EAST TOWN CROSSING

The submitted civil plans contain review comments ("markups") that must be addressed prior to landuse approval as well as informational comments that can be addressed at time of civil application. Please refer to the DRT Letter "Action Items" for markups that must be addressed for landuse approval. [Prelim. Civil Dwg Part 2, Pg 1 of 15]

EAST TOWN CROSSING SEC. 26,35/ TWP. 20 N./ RGE. 4 E., W.M. PIONEER WAY E. FRONTAGE STORM PLAN

WATER MASTER PLAN

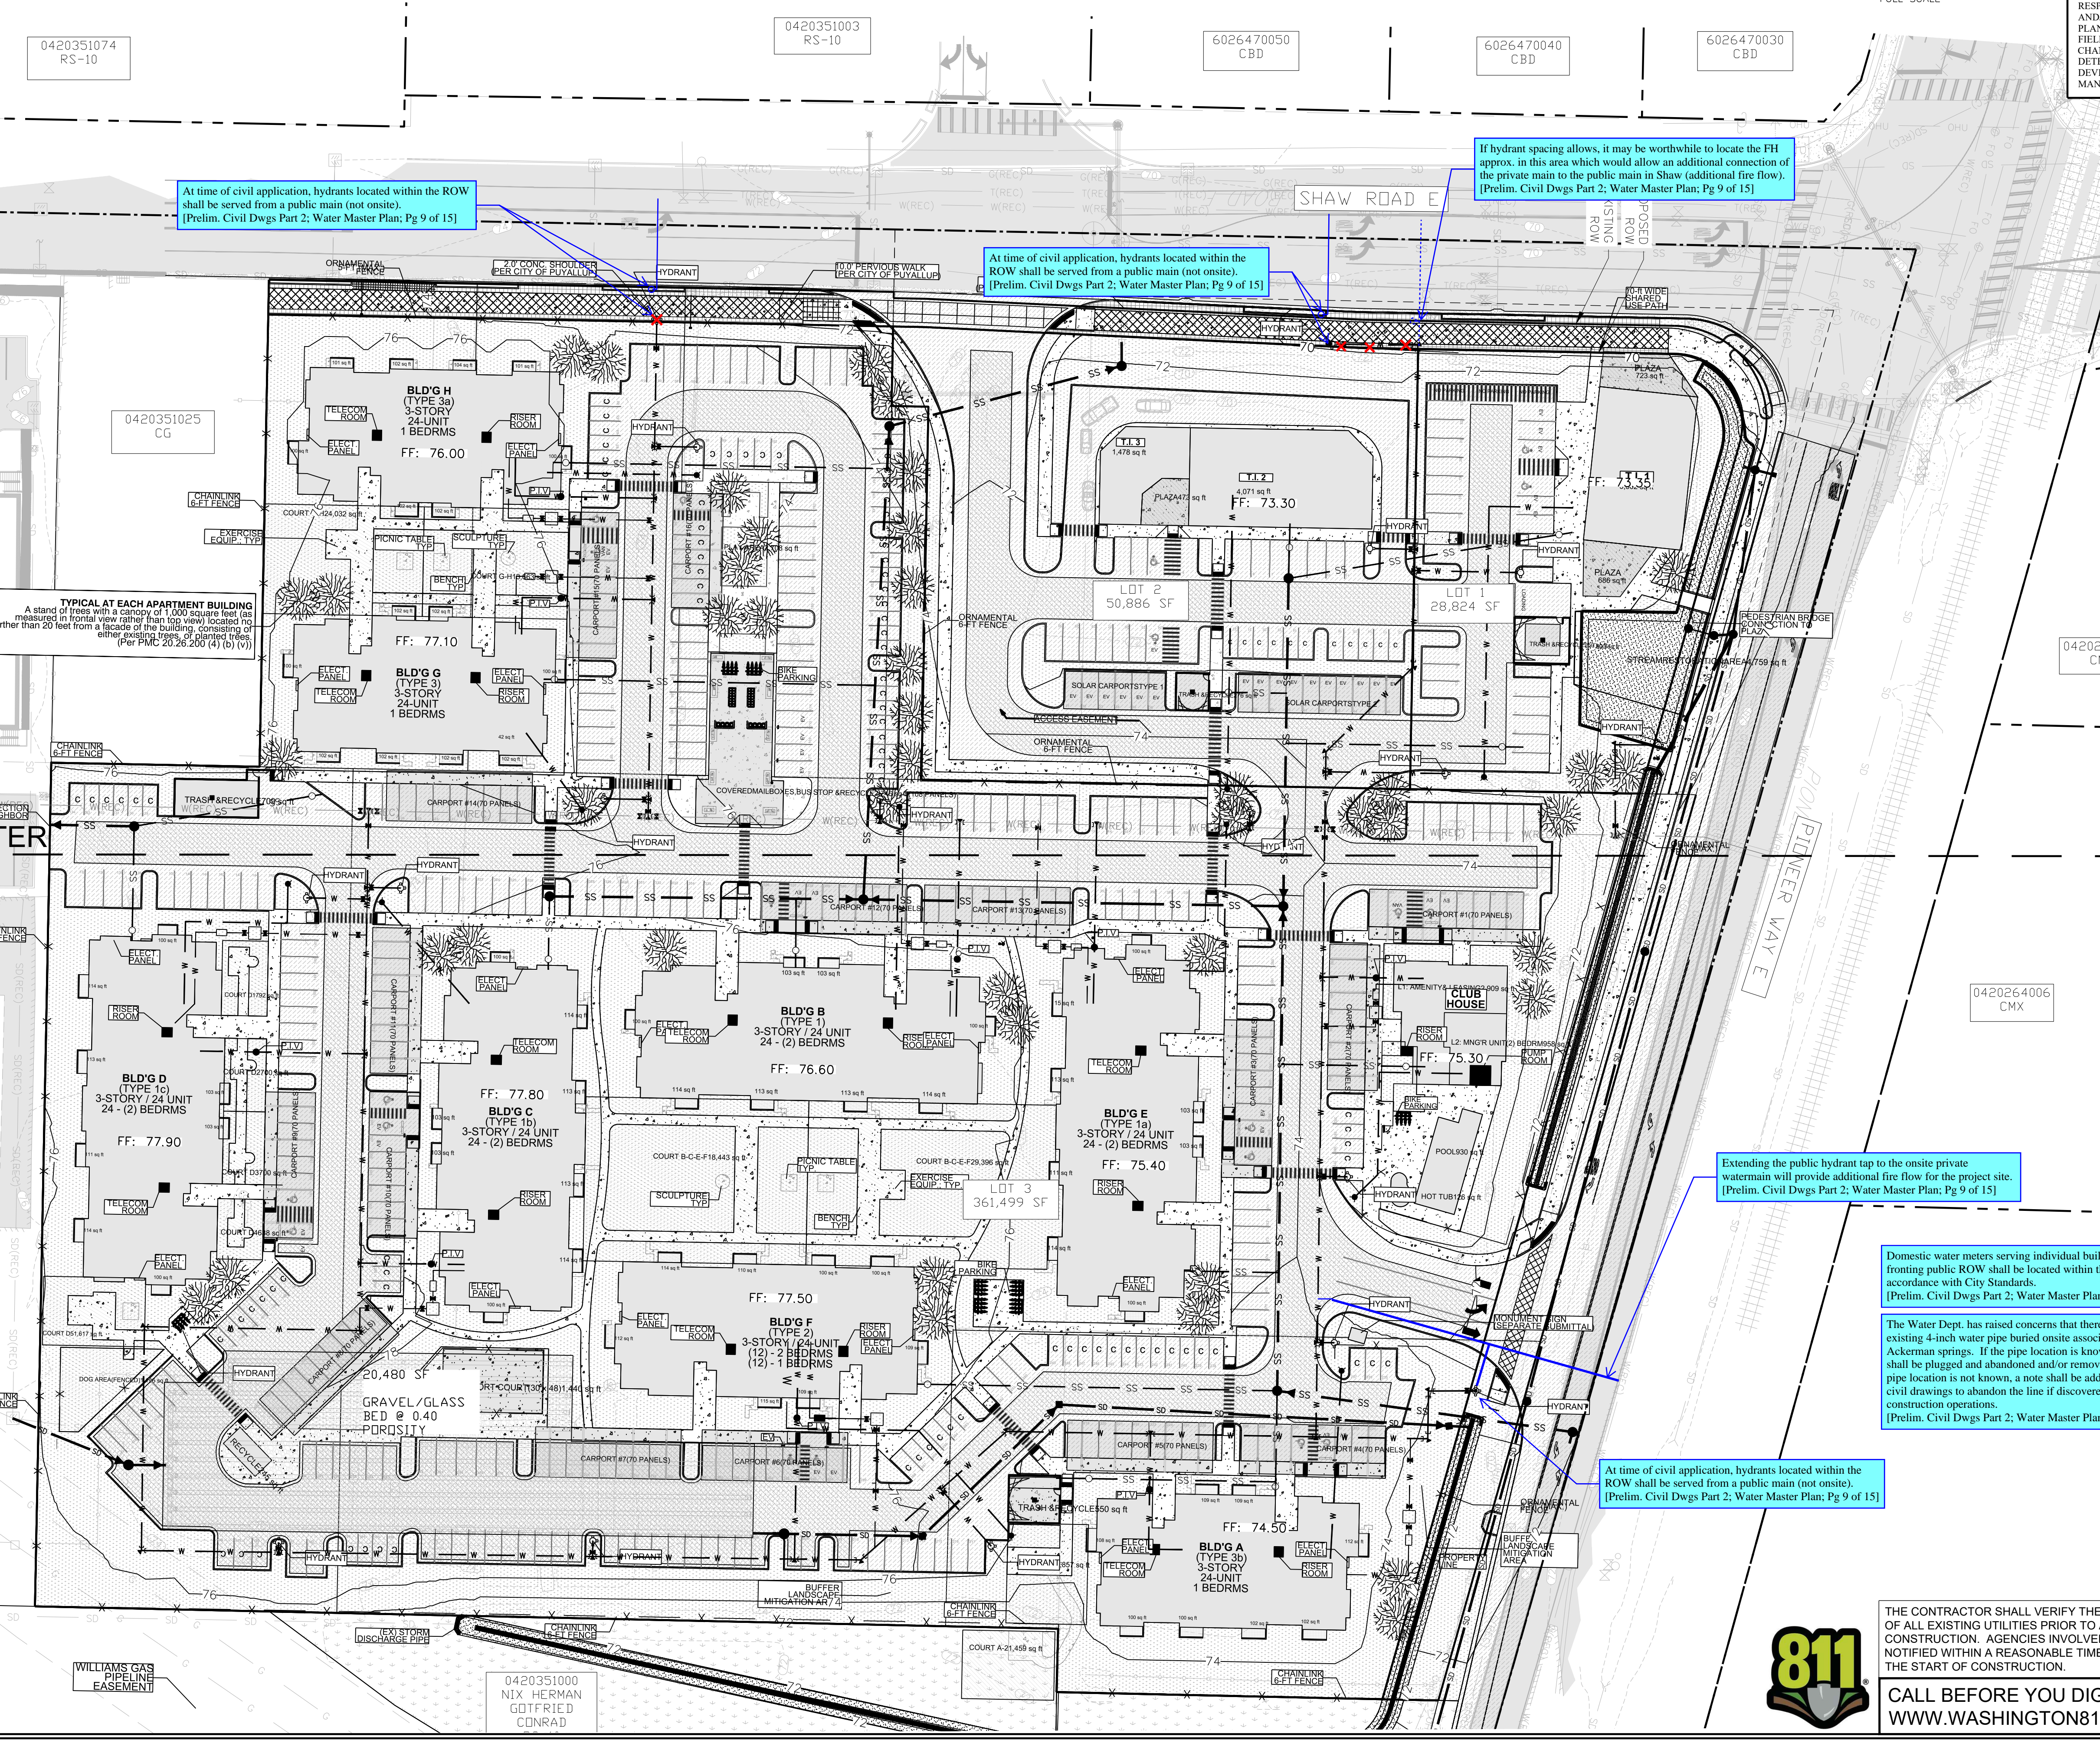
At time of civil application, hydrants located within the ROW shall be served from a public main (not onsite).
 [Prelim. Civil Dwg Part 2; Water Master Plan; Pg 9 of 15]

At time of civil application, hydrants located within the ROW shall be served from a public main (not onsite).
 [Prelim. Civil Dwg Part 2; Water Master Plan; Pg 9 of 15]

If hydrant spacing allows, it may be worthwhile to locate the FH approx. in this area which would allow an additional connection of the private main to the public main in Shaw (additional fire flow).
 [Prelim. Civil Dwg Part 2; Water Master Plan; Pg 9 of 15]

Extending the public hydrant tap to the onsite private watermain will provide additional fire flow for the project site.
 [Prelim. Civil Dwg Part 2; Water Master Plan; Pg 9 of 15]

Domestic water meters serving individual buildings fronting public ROW shall be located within the ROW in accordance with City Standards.
 [Prelim. Civil Dwg Part 2; Water Master Plan; Pg 9 of 15]

The Water Dept. has raised concerns that there may be an existing 4-inch water pipe buried onsite associated with Ackerman springs. If the pipe location is known, the pipe shall be plugged and abandoned and/or removed. If the pipe location is not known, a note shall be added to the civil drawings to abandon the line if discovered during construction operations.
 [Prelim. Civil Dwg Part 2; Water Master Plan; Pg 9 of 15]

At time of civil application, hydrants located within the ROW shall be served from a public main (not onsite).
 [Prelim. Civil Dwg Part 2; Water Master Plan; Pg 9 of 15]

WATER PLAN WEST

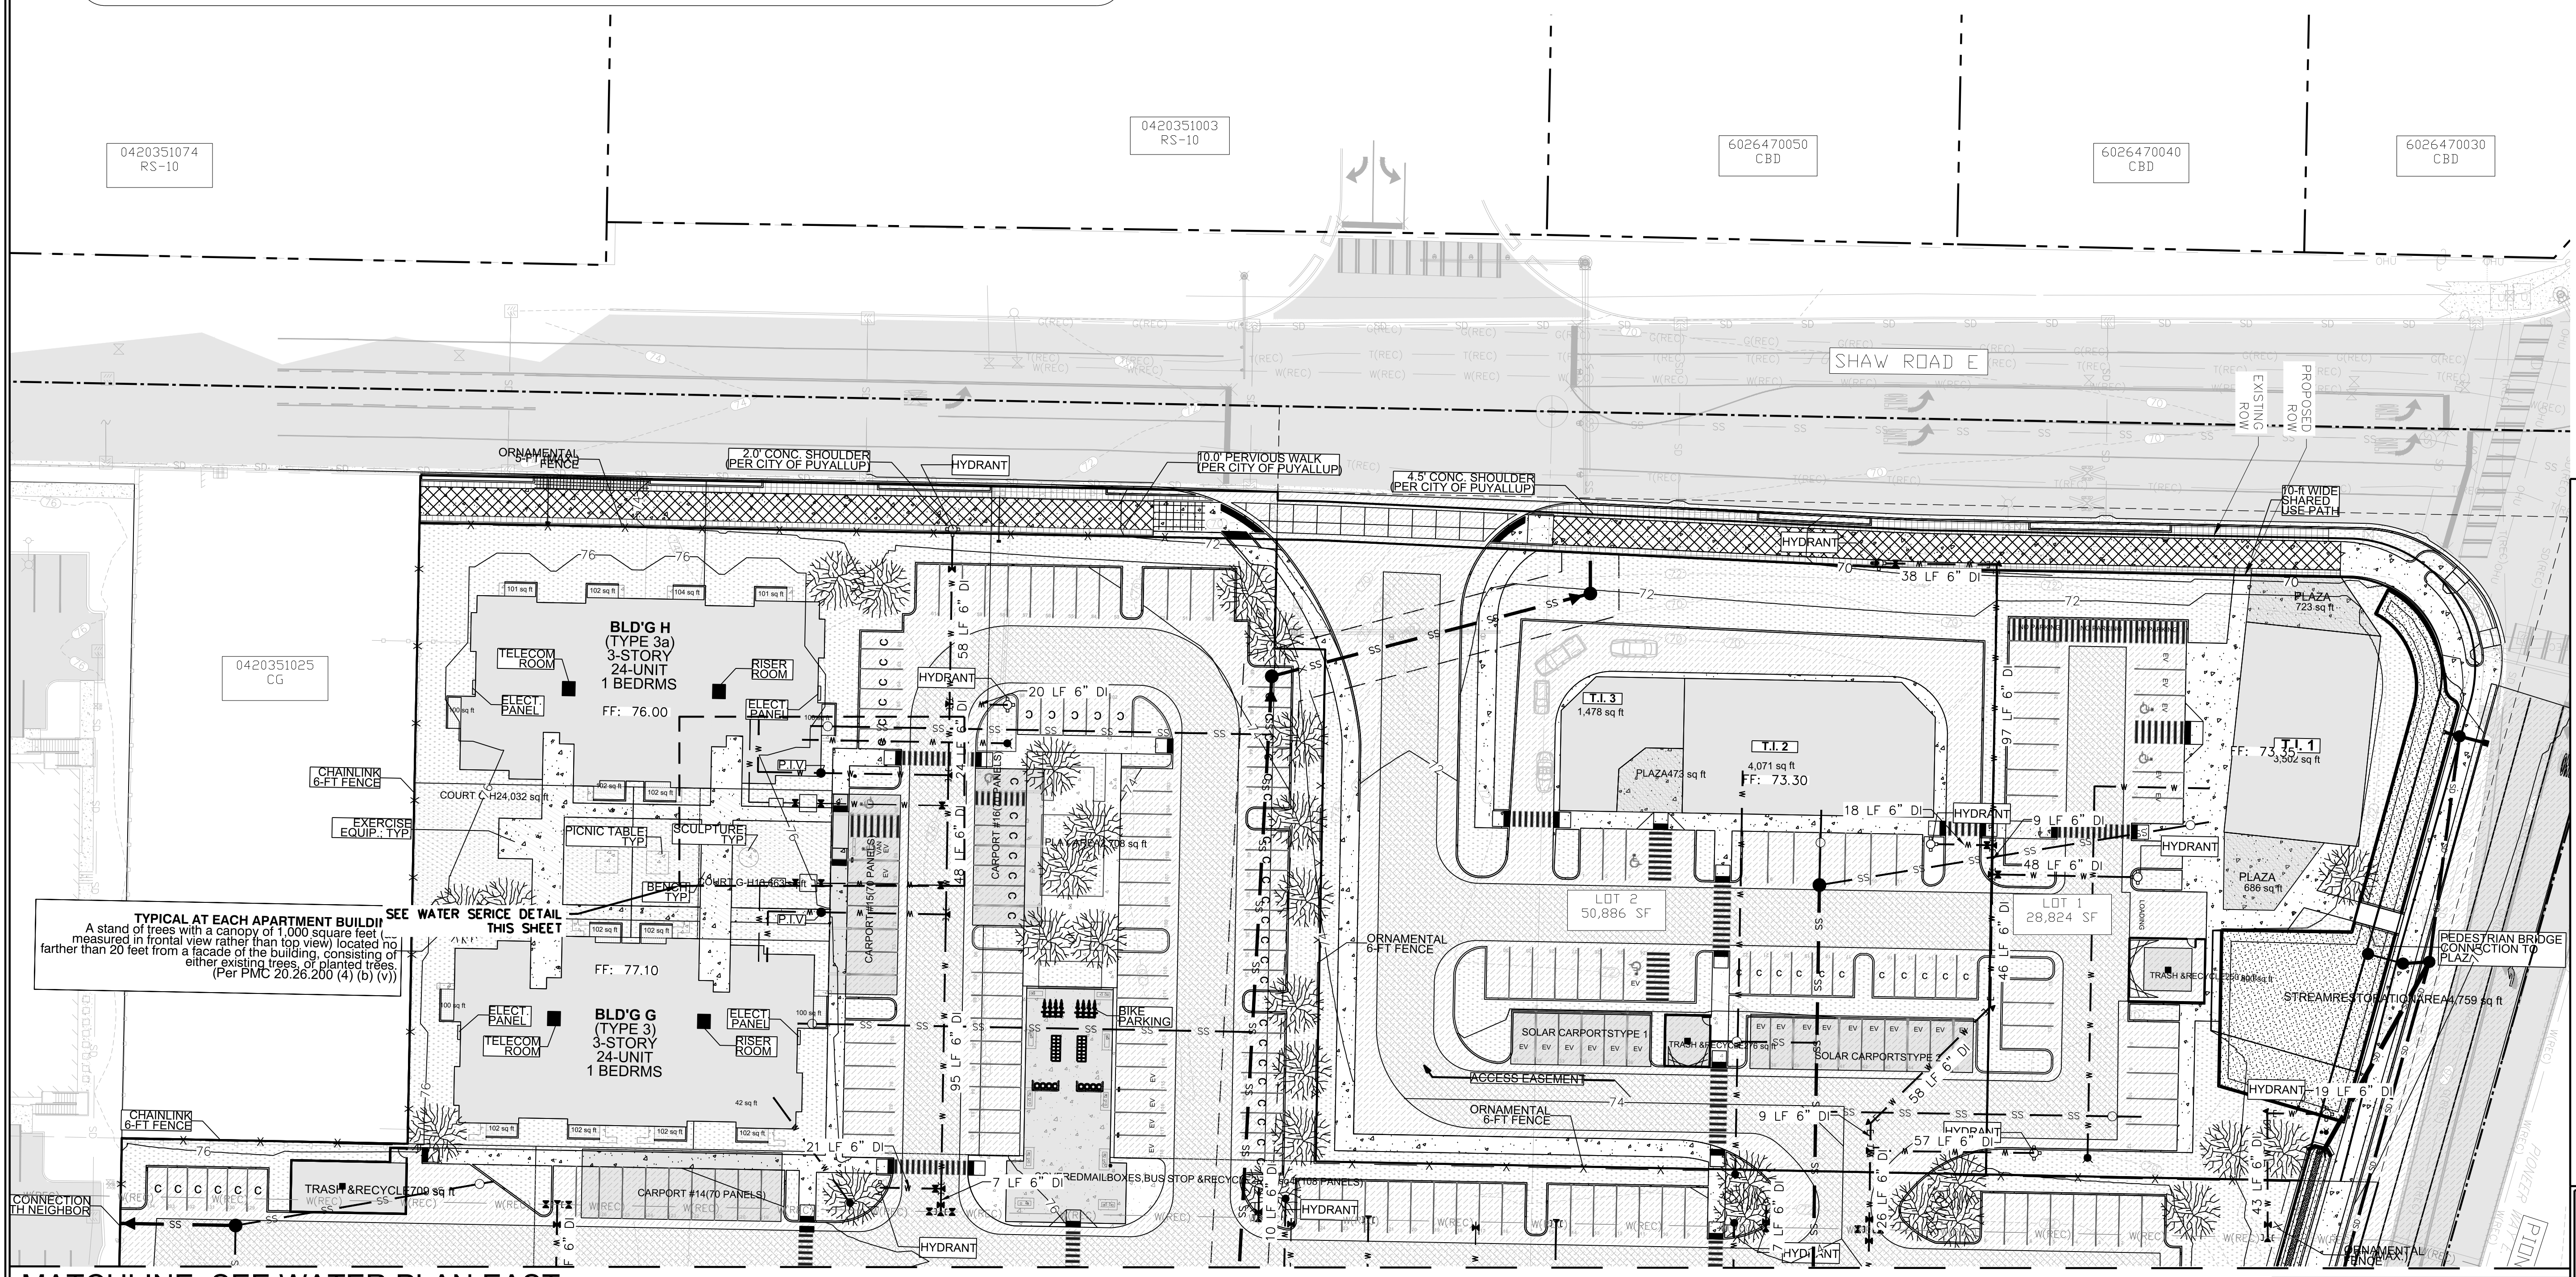
See comments on Water Master Plan sheet.
 [Prelim. Civil Dwg Part 2: Water Plan West; Pg 10 of 15]

WATER PLAN EAST

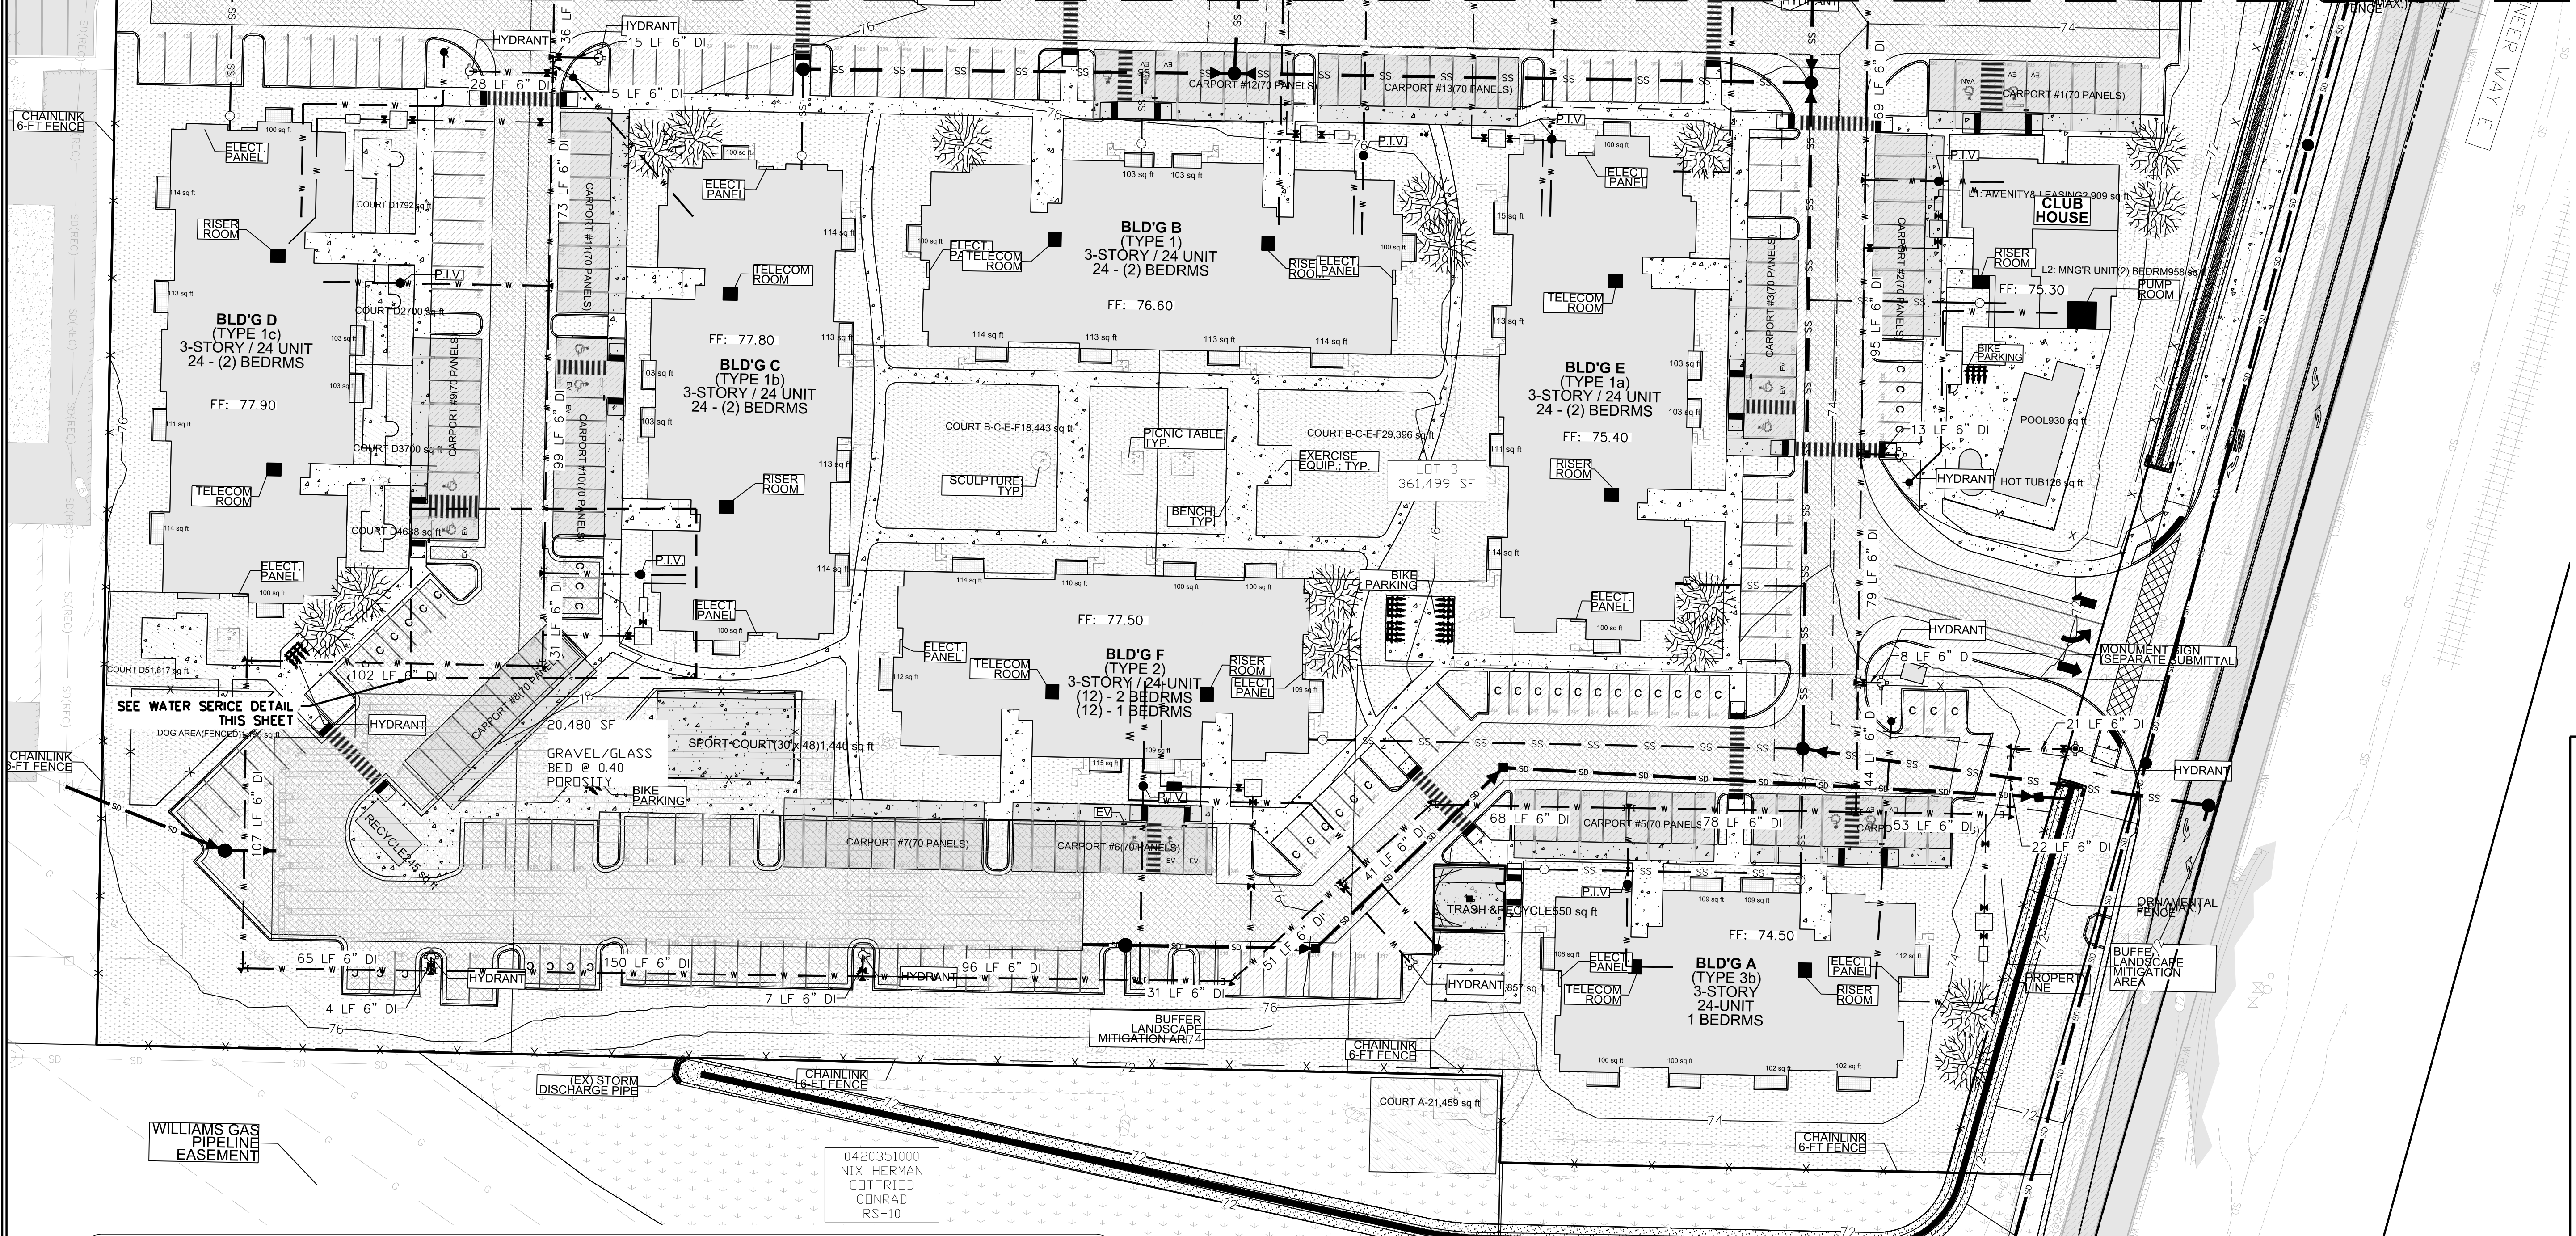
See comments on Water Master Plan sheet.
 [Prelim. Civil Dwg Part 2; Water Plan East; Pg 11 of 15]
